# UNITED STATES PATENT AND TRADEMARK OFFICE

APPLICATION NO.	FILING DATE	FIRST NAMED INVENTOR	ATTORNEY DOCKET NO.	CONFIRMATION NO.
10/542,374	07/14/2005	Hiroki Akatsuka	Q87773	7777

**Office Action Summary**

## DETAILED ACTION

Fig. 1

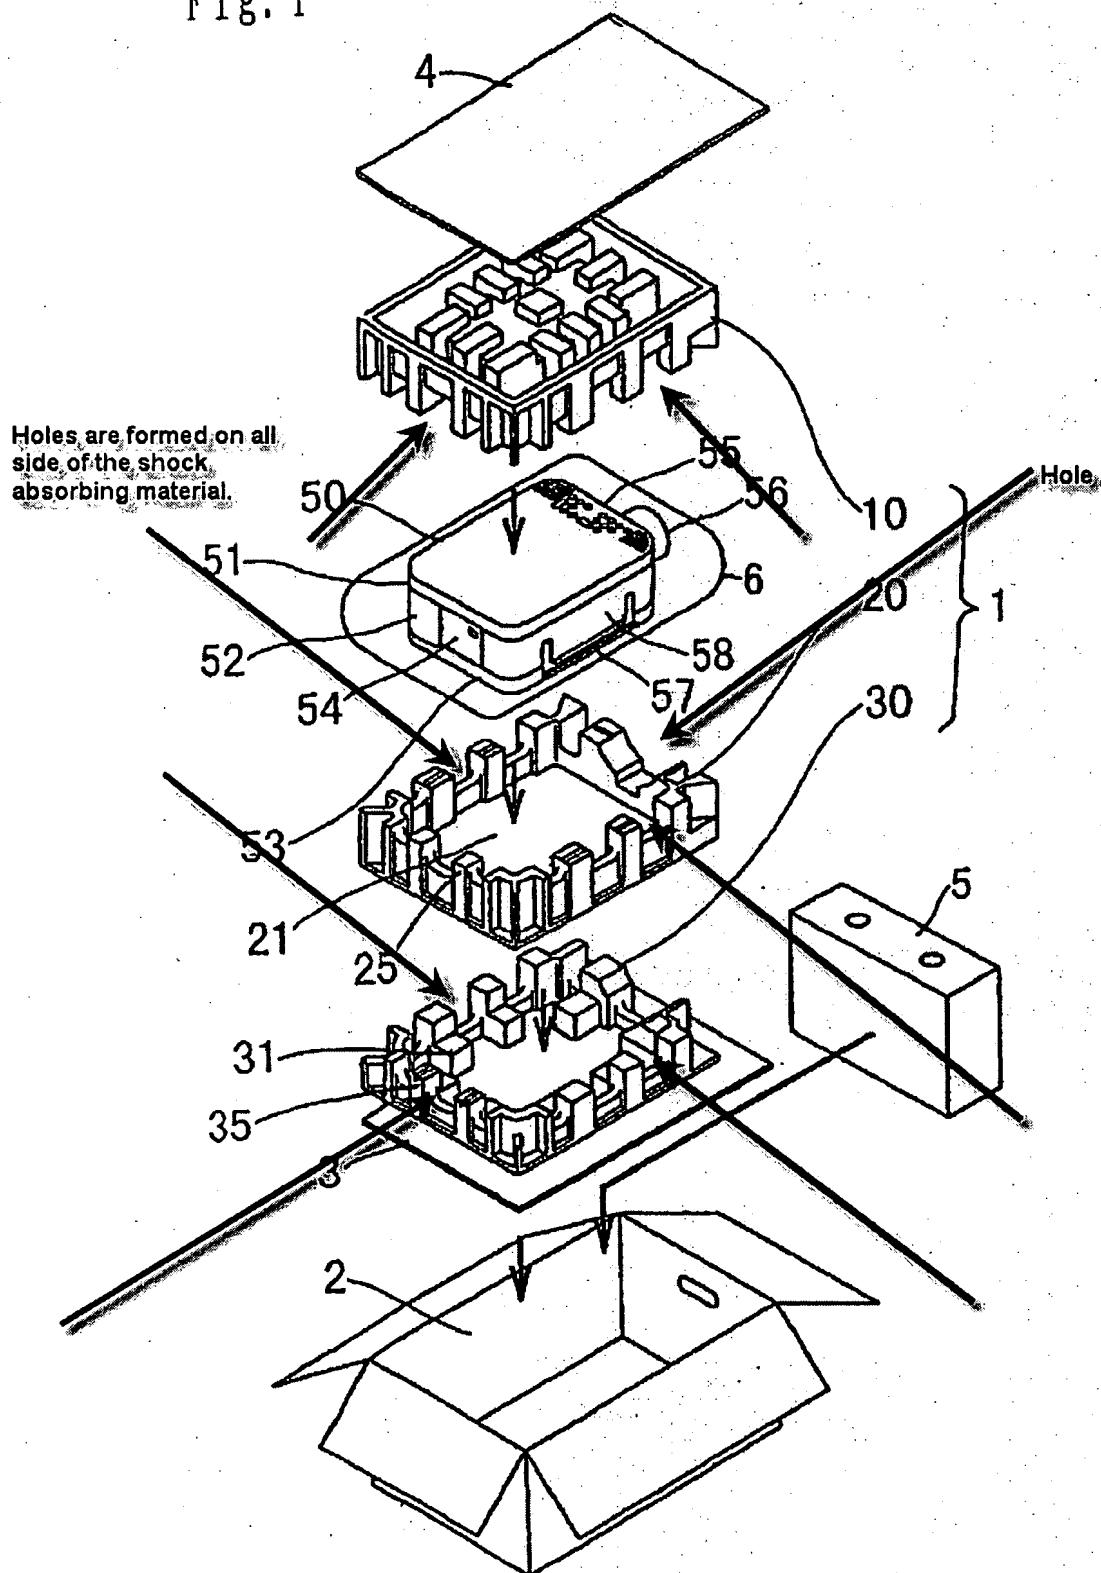
Accordingly, the examiner maintains that figures 1-8 of Koike clearly show that holes are formed on all sides of the shock absorbing material. For example, figure 1 shows opening spaces between projections, on all sides, of each of shock absorbing materials (10, 20, 30).

Attached is the copy of Fig. 1 of Koike reference, and the arrows provided pointing to the openings (or holes) on all side of the shock absorbing materials (10, 20, 30), and each shock absorbing material is a single pad.
